Staff Report for Administrative Approval
Hillside Review – Notice of Conditional Approval
Weber County Planning Division

Application Request: Consideration and action on a request to approve a Hillside Review for the Mountainside and Parkside Subdivisions in The Bridges PRUD.
Applicant: Bridges Holding Company, LLC
Authorized Representative: Eric Householder
File Number: HSR 2016-04

FIGURE 19

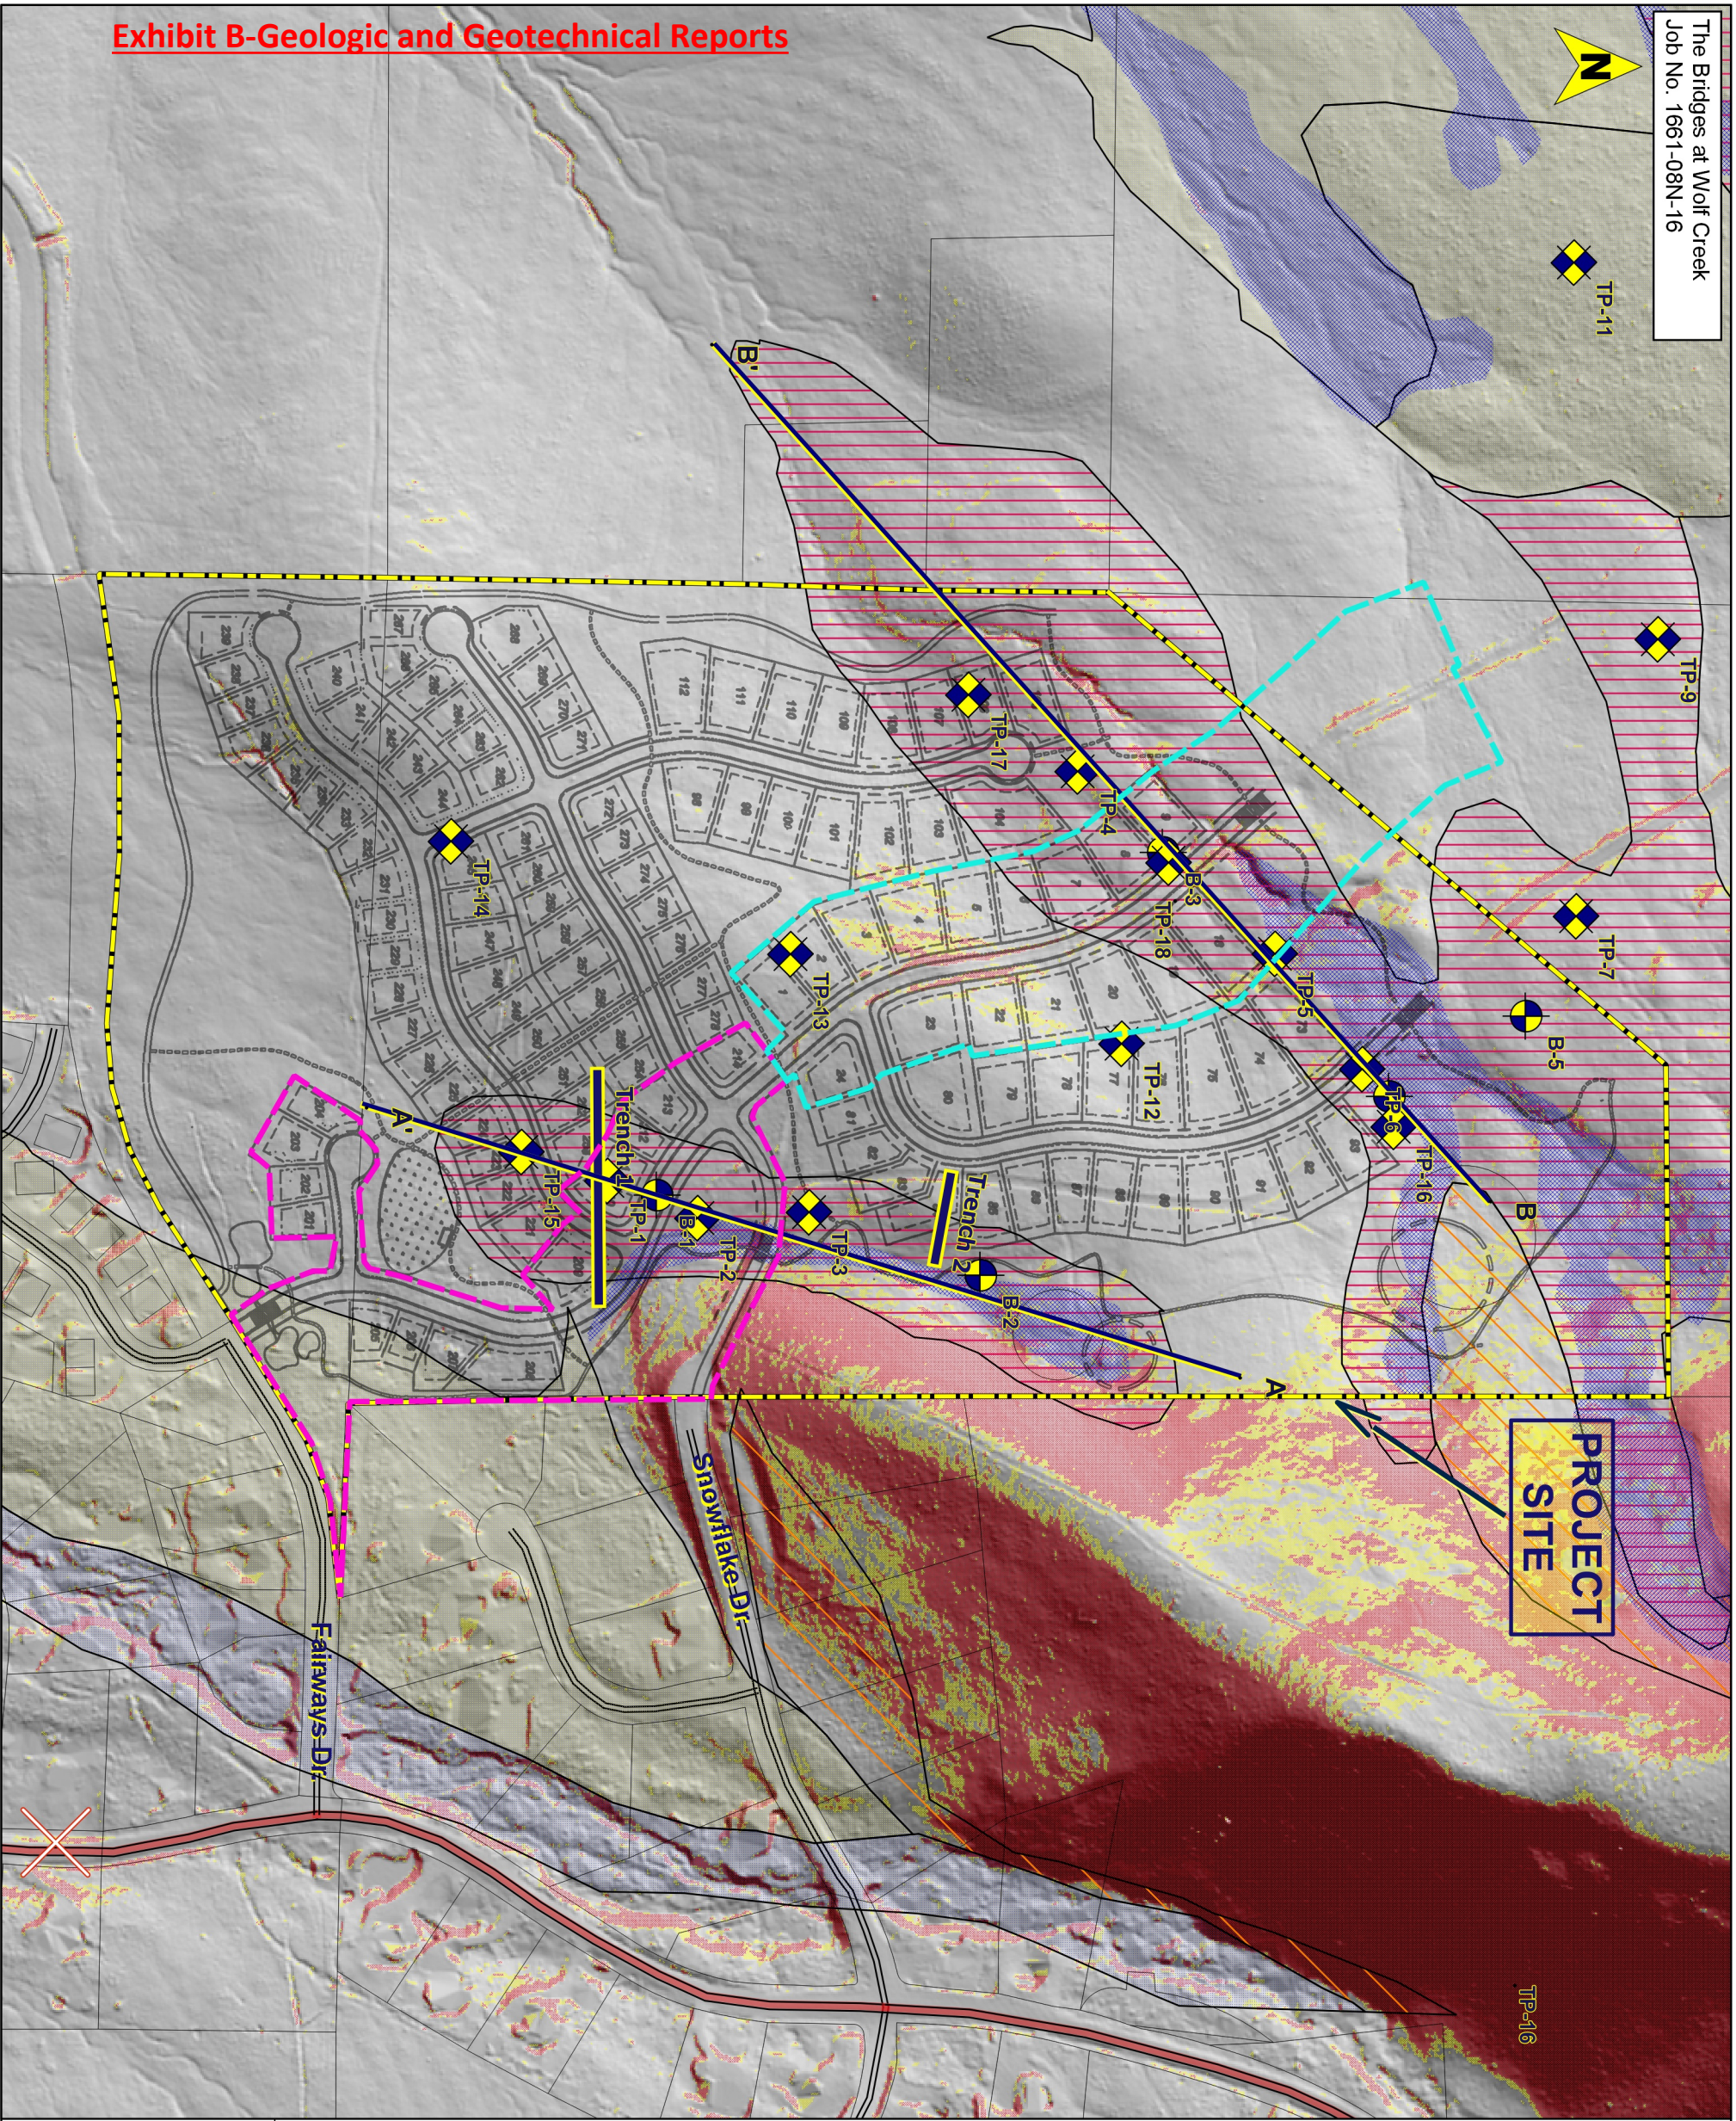
Weber County Engineering Division: The Engineering Division granted approval on August 16, 2016. The approval is subject to the applicant following all recommendations found in the applicable Geotechnical and Geological Investigation Reports including the following conditions:

1. Each lot which has any designation of Landslide potential per Figure 19 will need to be addressed with an individual geologic study.
2. Future roadways be addressed per the geologic study or roadways be realigned to avoid the hazard as shown on Figure 19.
